Southampton Junction 8 Improvement Scheme

Details of highway design changes

PCF stages 3-5

The Highways England (M27 Southampton Junction 8 Improvement Scheme
– M27 Junction 8 and Windhover Roundabout)
(Special Road) Compulsory Purchase Order 2021

Figure 4-1 – Lane reference plan

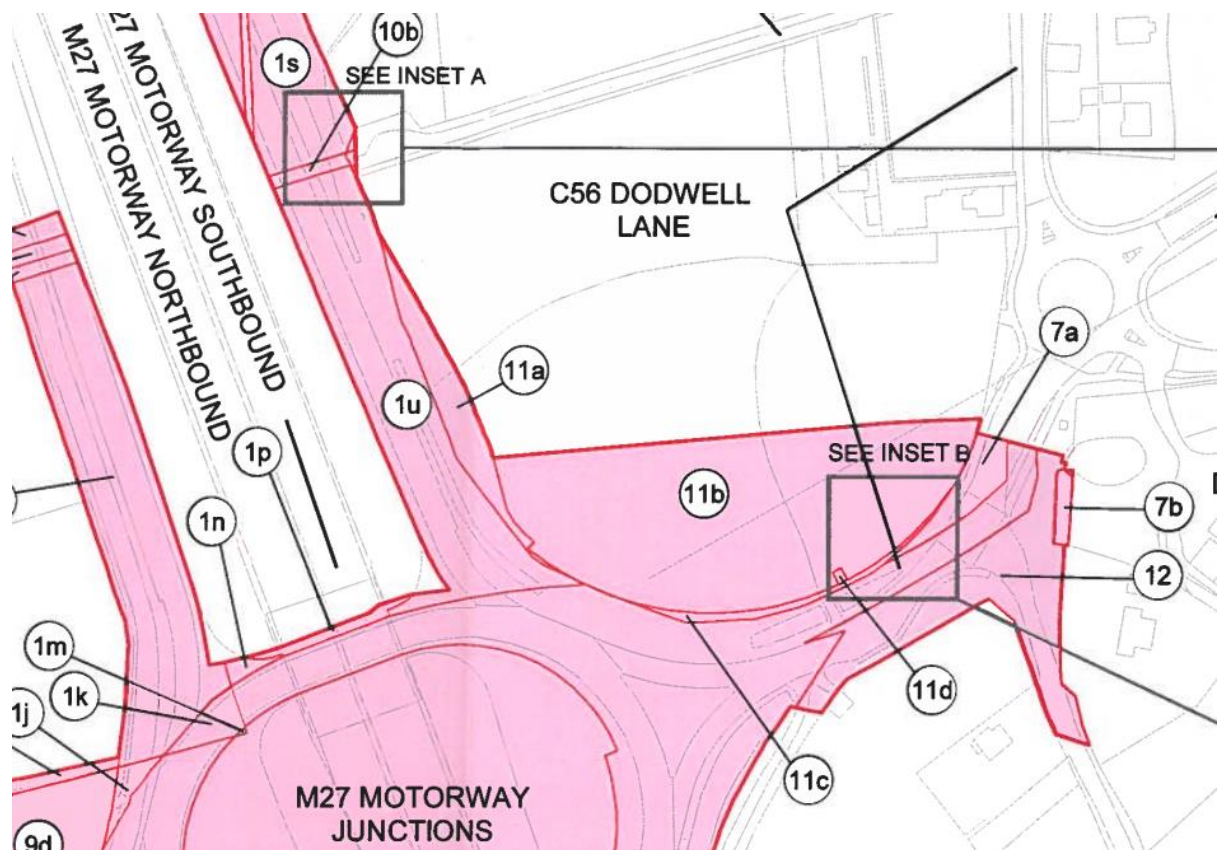
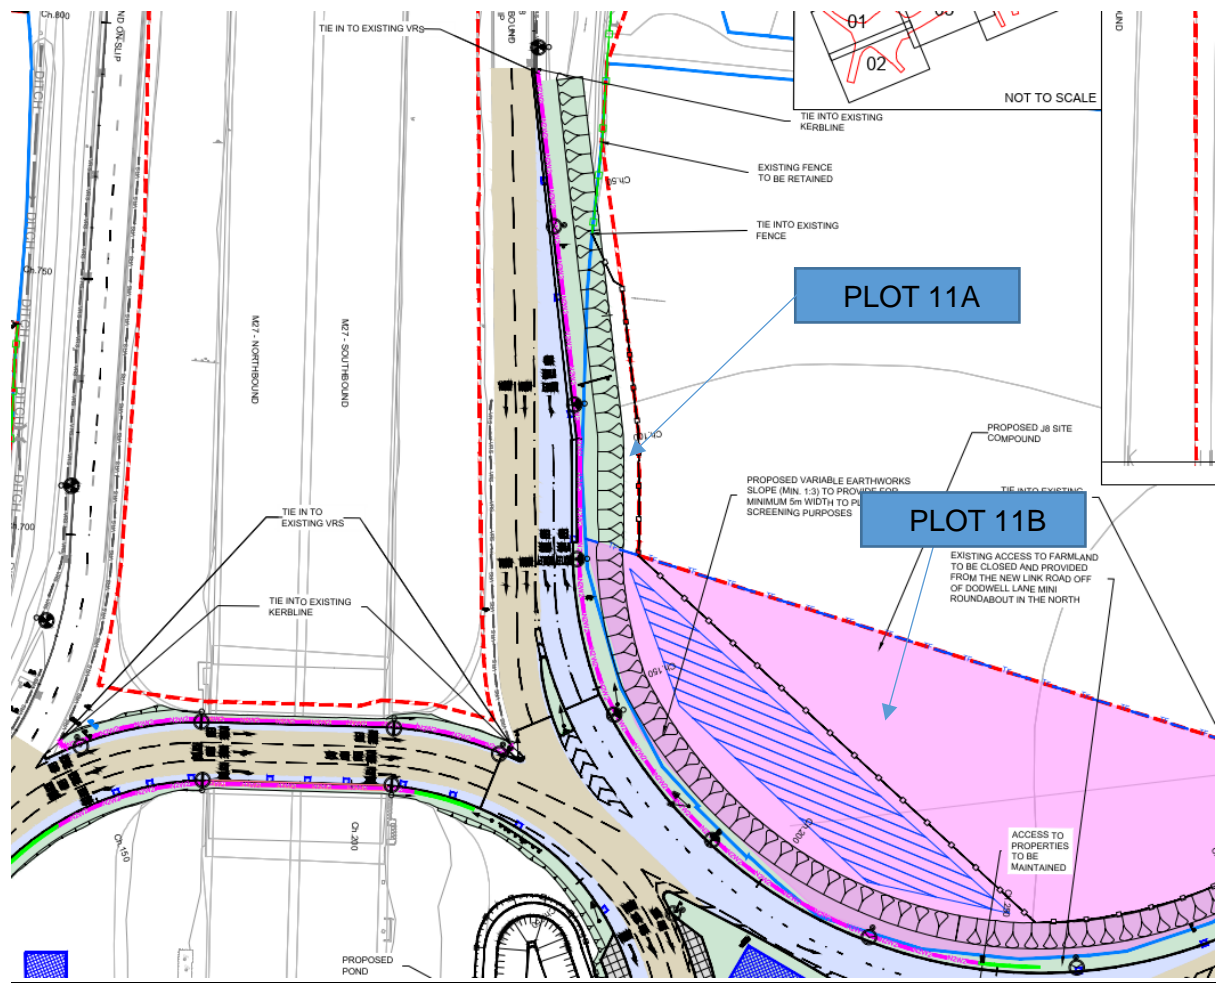
- 4.3. The Stage 3 design included widening of the carriageway into the nearside verge to create an additional two lanes. This resulted in four lanes on the approach to the junction 8 circulatory carriageway.
- 4.4. A splitter island between lanes two and three was also proposed to provide separation between the two lanes dedicated for Dodwell Lane and the two lanes entering the roundabout circulatory carriageway.
- 4.5. Figure 4-2 below demonstrates this layout.

- 4.6. In PCF Stage 5 the Stage 5 delivery team inherited the design with four lanes on the approach to the roundabout. As part of the design development, the team tested reducing the number of lanes from four to three in the traffic model which confirmed that there was sufficient capacity within the three lanes for the forecast traffic flows.
- 4.7. The reduction from four lanes to three lanes was taken forward and implemented in PCF Stage 5. The current design now provides three lanes on the approach to the junction 8 roundabout. The splitter island between lanes two and three has also been removed. This has reduced the amount of carriageway widening required in the nearside verge providing more room for the watercourse diversion, flood compensation area and mitigation planting.
- 4.8. Figure 4-3 below demonstrates this revised layout.

Figure 4-4 – Stage 3 layout

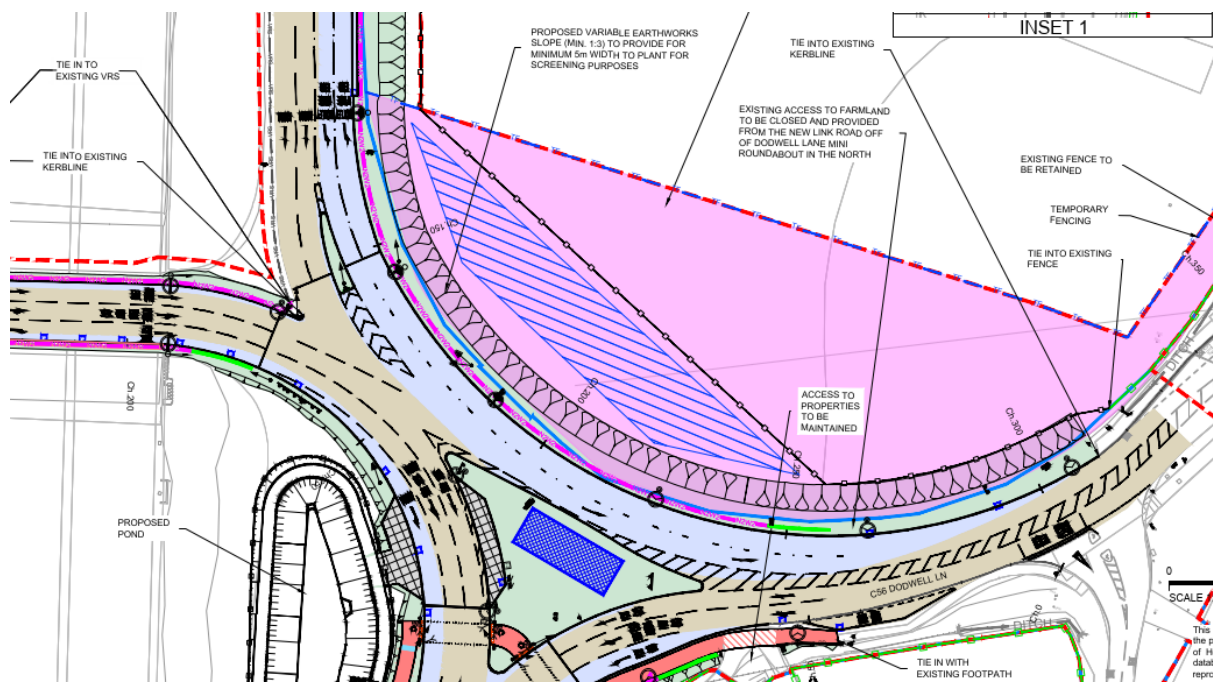
- 4.9. The splitter island on Dodwell Lane was designed to standard albeit a slightly unconventional shape as it was required to accommodate a drainage attenuation tank.
- 4.10. The stage 3 design provided hatched road markings from the end of the splitter island along Dodwell Lane to tie into the existing hatched road markings.
- 4.11. Figure 4-4 below demonstrates this layout.

- 4.12. During Stage 5 the drainage attenuation tank was removed from the design as not required. In Stage 3, the proposed splitter island was aligned in such a way as to accommodate the tanks – this shown in Figure 4-4.
- 4.13. Therefore with the removal of the need for this tank, this has enabled the splitter island has been realigned to a more conventional layout.
- 4.14. The splitter island has been extended down Dodwell Lane beyond the Dodwell Lane side road junction. This was at the request of Hampshire County Council to provide physical segregation to enforce the prohibition of right turn movements in and out of Dodwell Lane side road
- 4.15. Figure 4-5 below demonstrates this layout.

Figure 4-6 – Stage 3 layout

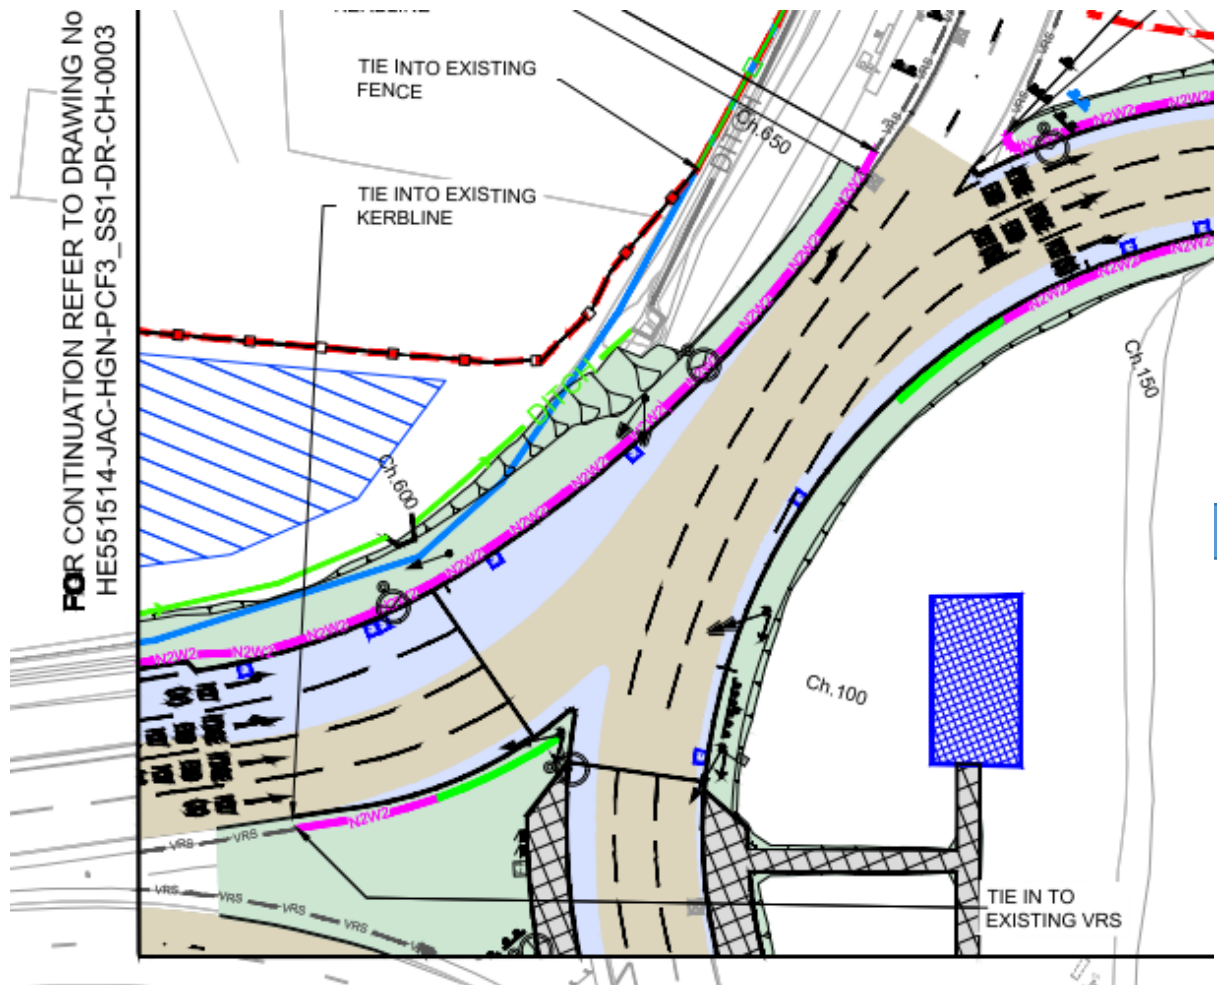
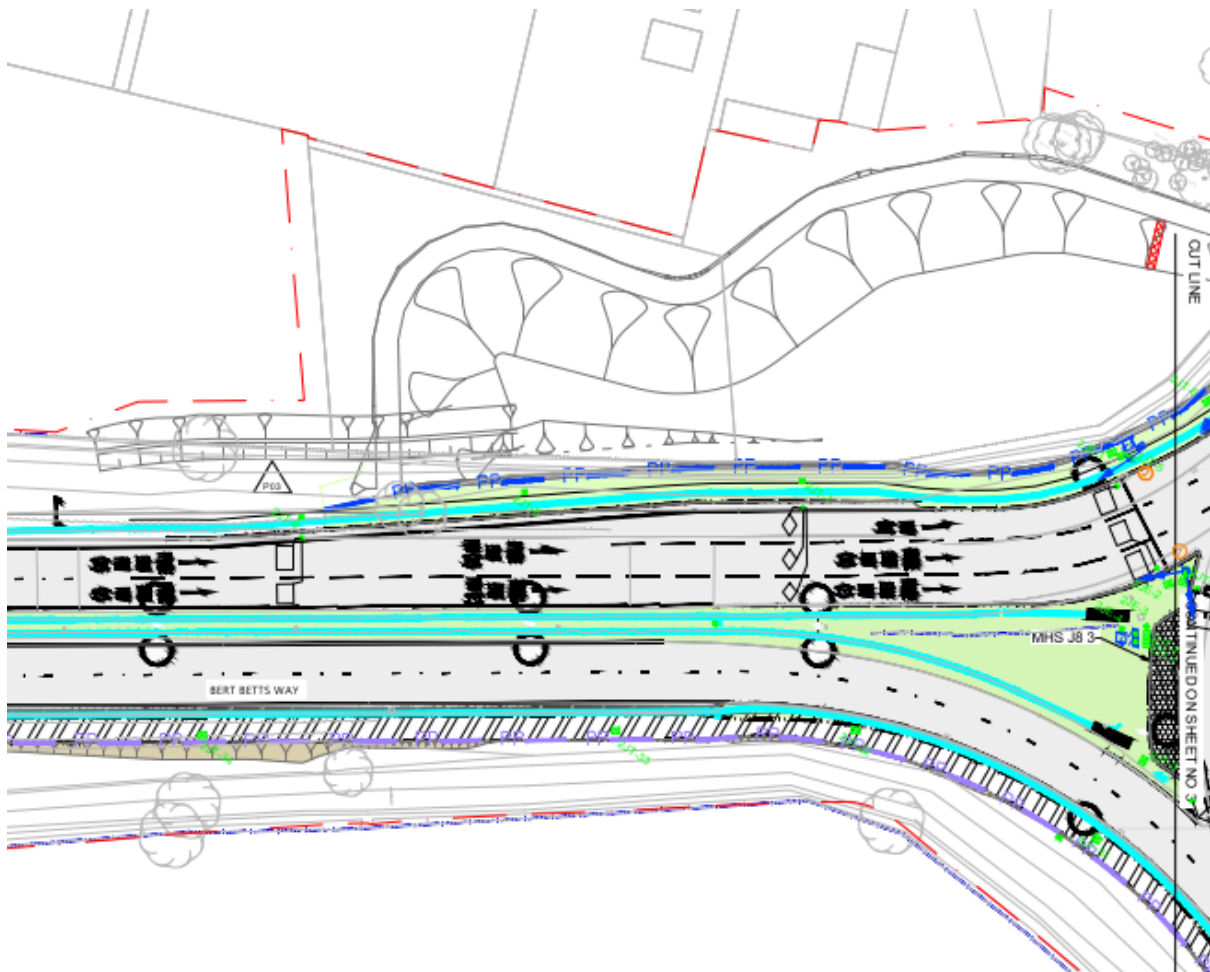
- 4.16. The Bert Betts Way east bound approach to the M27 junction 8 roundabout is currently two lanes and the PCF Stage 3 design included widening of the carriageway into the nearside verge to create an additional two lanes. Resulting in four lanes on the approach to the junction 8 circulatory carriageway.
- 4.17. Figure 4-6 below demonstrates this layout.

- 4.18. In PCF Stage 5 the design and delivery team inherited the design with four lanes on the approach to the roundabout. As part of the design development, we tested reducing the number of lanes from four to three in the traffic model which confirmed that there was sufficient capacity within the three lanes for the forecast traffic flows.
- 4.19. The reduction from four lanes to three lanes was taken forward and implemented in PCF Stage 5. The current design now provides three lanes on the approach to the junction 8 roundabout. This has reduced the amount of carriageway widening required in the nearside verge.
- 4.20. Figure 4-7 below demonstrates this revised layout.
